**SAN ANTONIO WATER SYSTEM  
CENTRAL WATER INTEGRATION PIPELINE BITTERS PUMP  
STATION & SEGMENT 5-3**

**SAWS JOB NUMBER 18-8613  
SOLICITATION NO. CO-00184**

**ADDENDUM NO. 5  
August 10, 2018**

**E-2235**

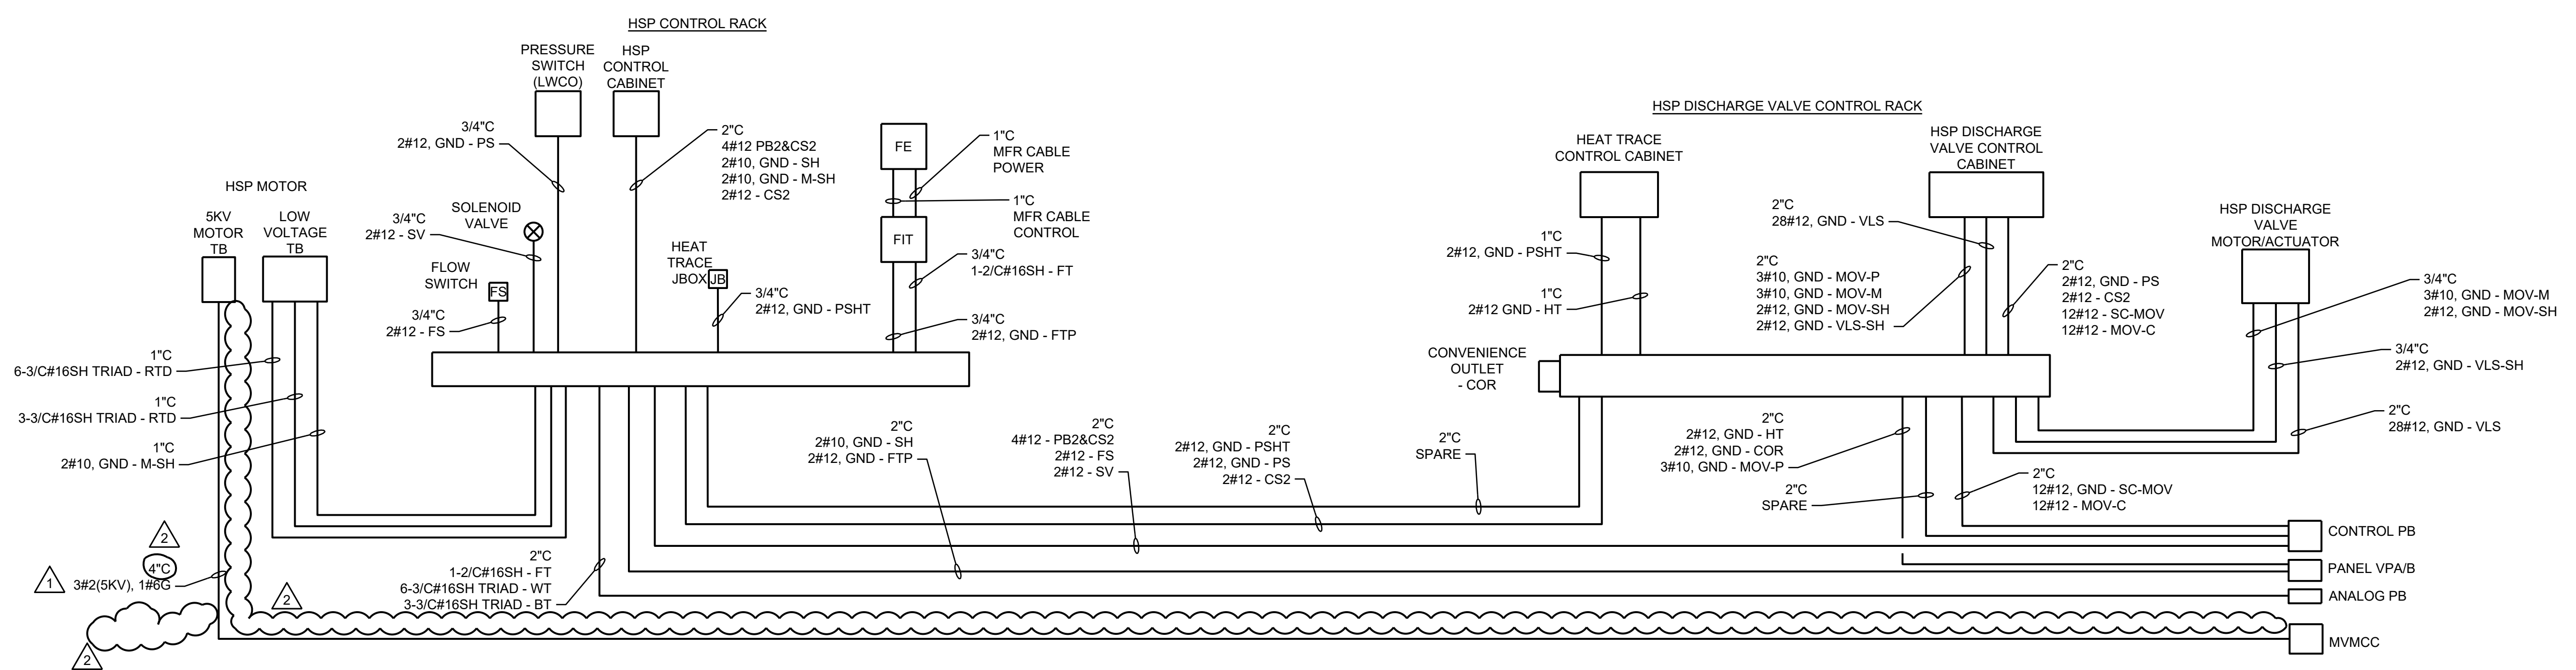
Question No.	Question	Answer
1	Plan sheet E2205, duct bank section A, indicates (1) 4" conduit going to each of the HSP motors. HOWEVER, addenda 4, revised diagram 4, indicates that the conduit size to be 3" serving the motor, and also shows another 3" spare to be furnished which does not appear on the section detail on E2205. Can you clarify the correct conduit size/qty to the HSP motors?	One (1) 4" conduit for each HSP will be required. This is reflected in the changes to SHEET E-2235 per Addendum No. 5.
2	Background: With respect to the finish grade immediately outside the tank, Section "A" in Sheet S-2231 and Section "A" in D-2230 (both in Addendum No. 3) contain the instruction that for Finish Grade elevation we must consult the Civil Drawings. According to civil drawing Sheets C-2212, C-2216 and C-2217 (Plan), finish grade is 865'. However, according to many other drawings (including Section B in Sheet S-2231, and the cross-sections in C-2217) and Q&A Item 6 of Addendum No. 3, finish grade is 6" below the top of the footing, namely at elevation 866.5'. Question: Please confirm that the correct finish grade elevation is 6 inches below the top of the tank footing, namely at 866.5'; and that therefore the finish grade elevation 865' shown in Sheets C-2212, C-2216 and C-2217 is incorrect.	The correct tank finished floor elevation is 867.0 and the correct ground finish grade adjacent to the tank footing is 866.5 as shown on sheets C-2216 and C-2217 issued in Addendum 4.
